CITY OF LOS ANGELES
INTER-DEPARTMENTAL CORRESPONDENCE

8150 W. Sunset Bl
DOT Case No. CEN 16-44691

Subject: **UPDATED TRANSPORTATION ANALYSIS FOR THE PROPOSED MIXED-USE PROJECT LOCATED AT 8150 WEST SUNSET BOULEVARD**

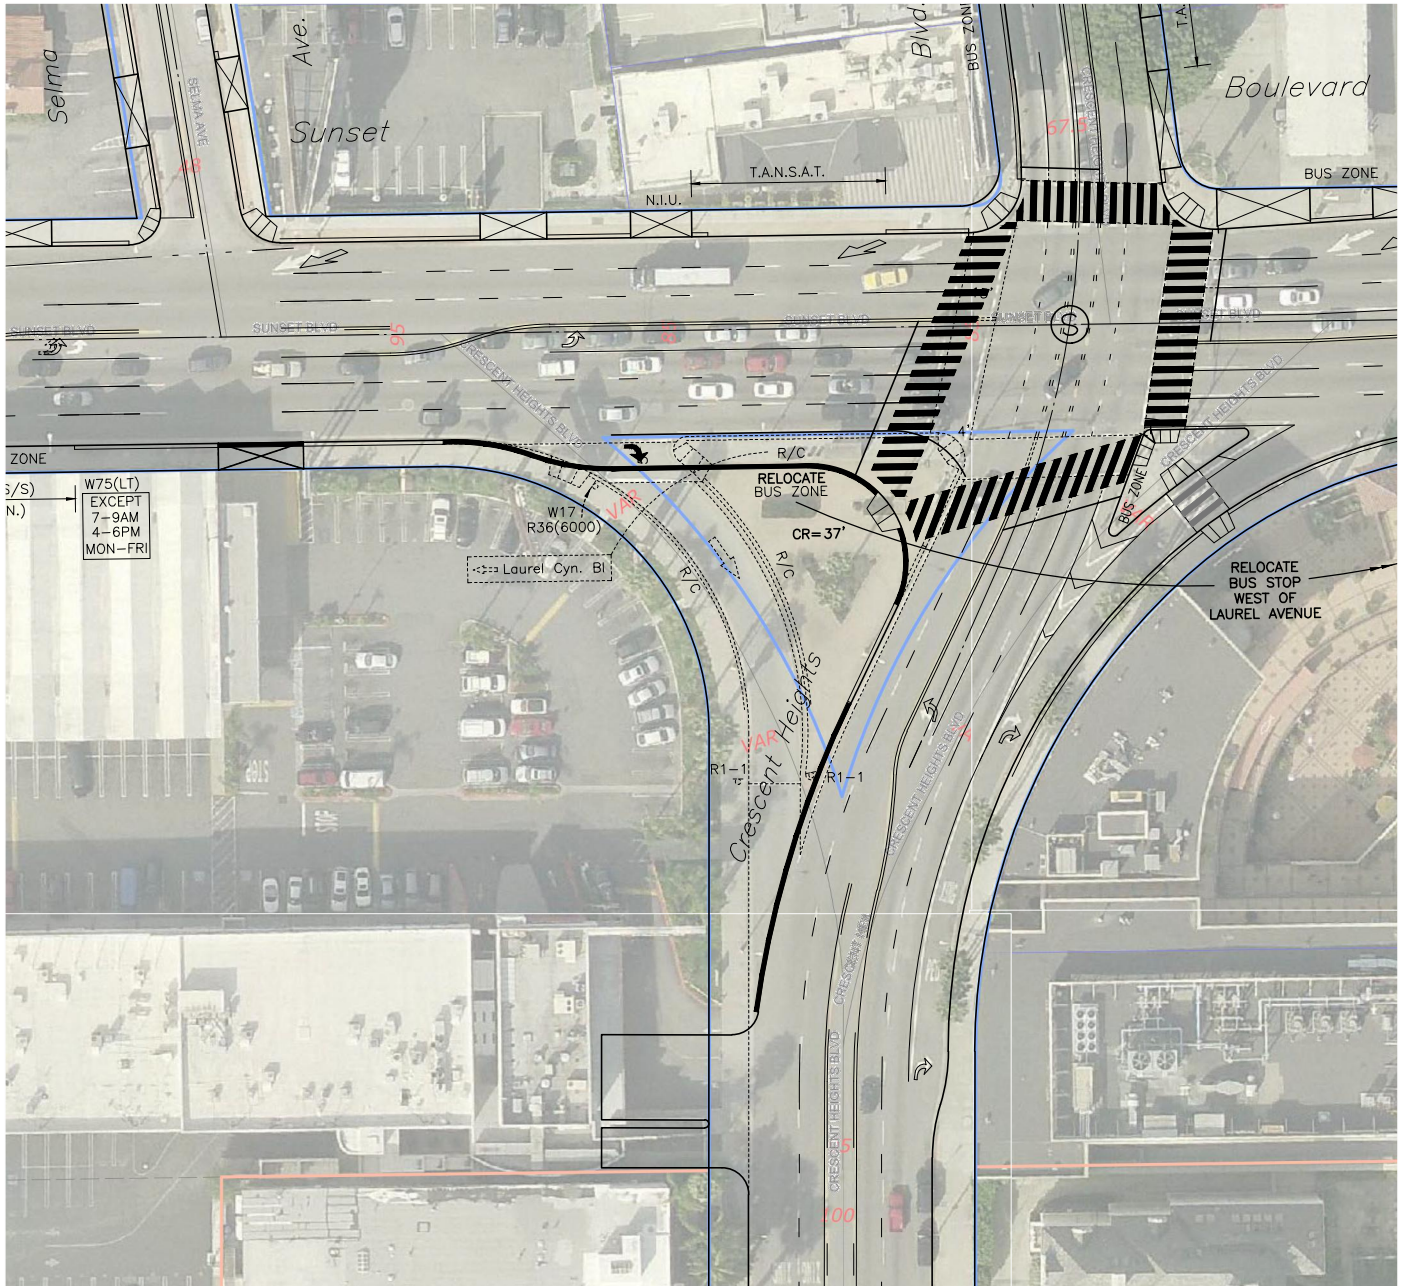
To enhance and activate the pedestrian environment adjacent to the project, the project proposes to reconfigure the southwest quadrant of the intersection of Sunset Boulevard and Crescent Heights Boulevard. The improvement would remove the current sweeping eastbound right-turn lane on Sunset Boulevard that is stop-controlled before merging with southbound Crescent Heights Boulevard, and install a typical exclusive right-turn lane at the intersection. The unused “triangle” section would then be reconfigured to provide a new public “plaza” area adjacent to the northeast corner of the project site as illustrated in **Attachment 3**.

To accommodate the exclusive eastbound right-turn lane, the south side of Sunset Boulevard would be widened and the west side of Crescent Heights Boulevard between Sunset Boulevard and the project’s driveway would be reconstructed. Conceptually, this improvement is acceptable to DOT; however, to ensure optimal efficiency and safety of the intersection’s operations for all modes, the existing bus stop on the eastbound approach should be relocated from the near-side and the traffic signal may need to be upgraded to install northbound left-turn phasing and concurrent eastbound right-turn phasing (subject to review by DOT’s Hollywood/Wilshire District Office). These design issues should be discussed with DOT and Council District 4 prior to the commencement of the engineering plans for this improvement.

This section of Sunset Boulevard has been identified as a roadway within the High Injury Network (HIN), which spotlights streets with a high concentration of traffic collisions that result in severe injuries and deaths, with an emphasis on those involving people walking and bicycling. The proposed improvement would result in enhanced safety by removing the sweeping eastbound right-turn lane, thus eliminating a pedestrian-vehicle conflict point.
